Service Letter No. 212

**Subject:** Nose Wheel Shimmy Dampener, Part No. 13086-00

**Models Affected:** All 1953 Model PA-22's with serial numbers 22-807 to 22-1614 inclusive, 22-1616 to 22-1631 inclusive, 22-1633 to 22-1635 inclusive, 22-1638, 22-1642, 22-1646 to 22-1648 inclusive, 22-1651, 22-1653, 22-1655, 22-1656, 22-1658 to 22-1661 inclusive, 22-1666, 23-1667, 22-1672, 22-1678, 22-1680, 22-1682 and 22-1683.

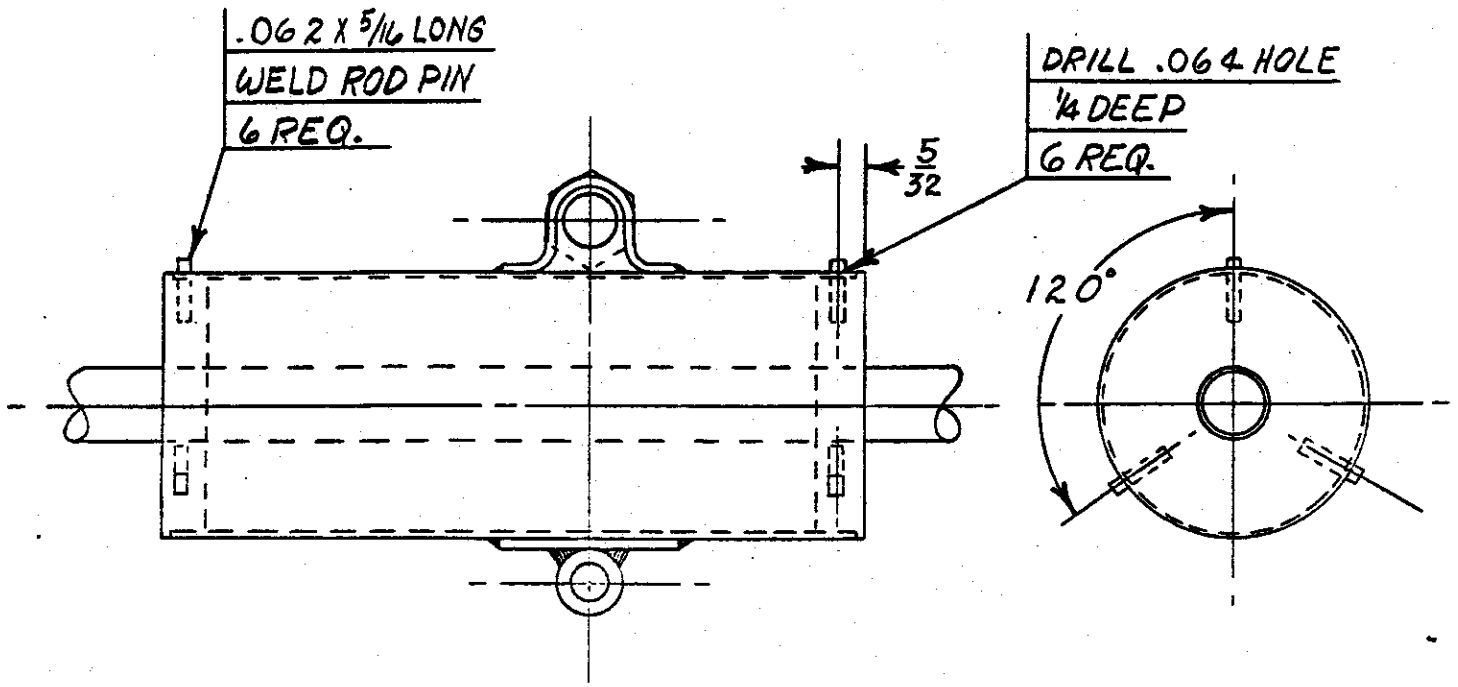
During the past few months we have received from the field a number of shimmy dampeners, part number 13086-00, on which a separation has occurred between the assembly body and the end plate. This separation was due to solder breaking loose and the internal fluid pressure plus the friction of the plunger forcing the end plate outward.

All production airplanes have been modified in accordance with the sketch shown on the reverse side of this Letter and it is felt that this modification can be satisfactorily executed in the field as a service-fix. Upon inspection if the shimmy dampener shows signs of separation, it will be exchanged free-of-charge at the nearest Piper Distributor or Dealer.

NOTE:

DRIVE PIN INTO EACH HOLE AND SOLDER END, COVERING  
PIN WITH SOLDER.
